INNOVATIVE KNITEX LIMITED

04 December 2022

Building Information

Factory Building: The structure is partially nine storied (G+8) reinforced concrete (RC) structure including a partial roof shed on 7th floor.

Floor layout

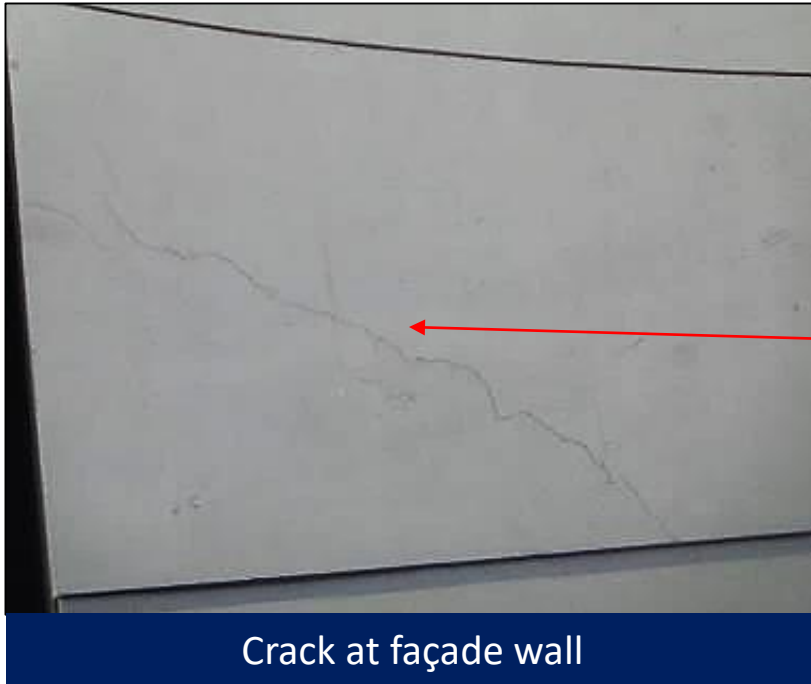
**Stress in column exceeds
normal design limit**

The cursory calculation indicates that column's (under water tank) stress exceeds the normal design limit considering a typical floor live load 2kPa, stair live load of 4 kPa, and minimum concrete strength of 16.31 MPa. The building engineer is required to review the design, loads, and column stresses for the marked columns based on in-situ material strength. Verify in-situ concrete stresses by 100 mm diameter cores from a minimum of 4 columns. Produce and actively manage a loading plan for all floors considering floor and column capacity.
